Certificate of Appropriateness

2624 N. Grant Boulevard, Grant Boulevard Historic District

Replace existing wood fence with 4' solid wood fence with upper 2' 50% at the front of the house. Rear fence will be 6' solid wood matching design of the front.

Date issued 3/27/2025

Fence design

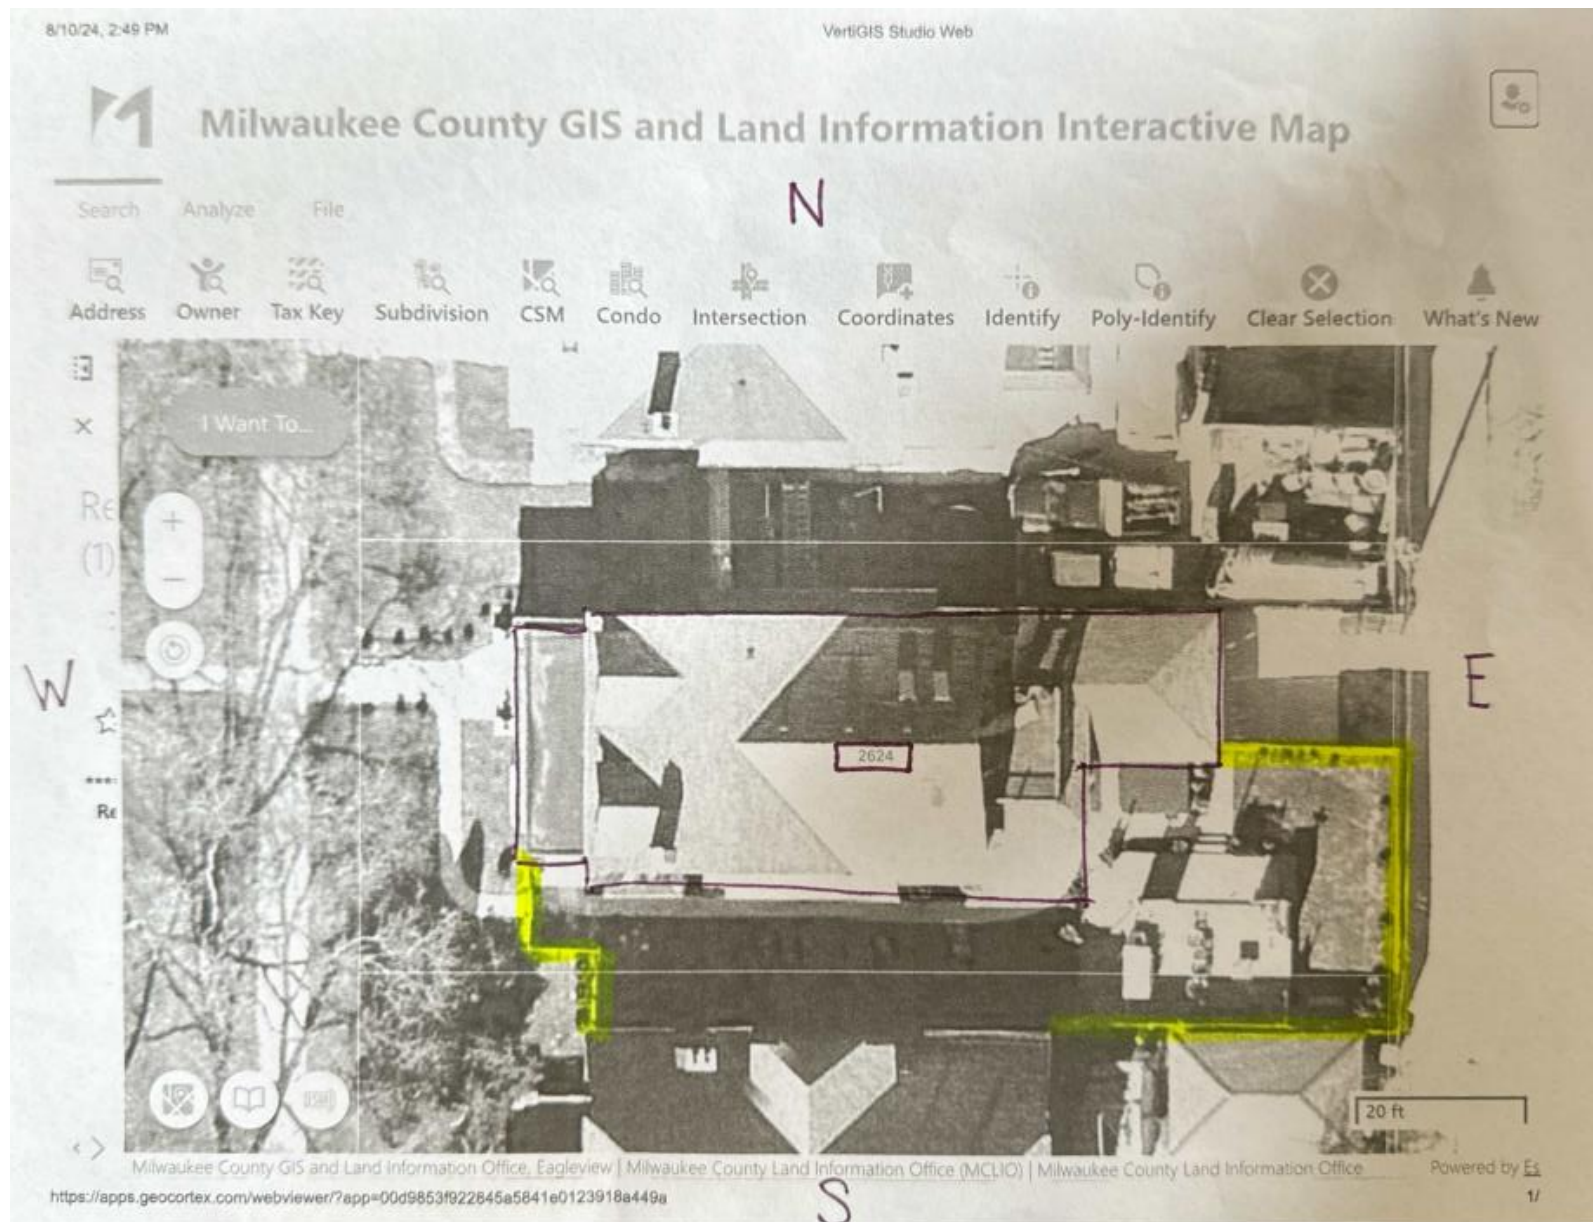
All wood must be smooth and equivalent to #1 grade cedar or better for use in rear and side yards. Sections of fence forward of or in line with the primary building's front setback must be clear grain. Wood fences must be painted or stained upon completion. Note: when new, bare wood is left exposed to the exterior elements for a period of only a week or two, the life of the finish subsequently applied to it will be decreased.
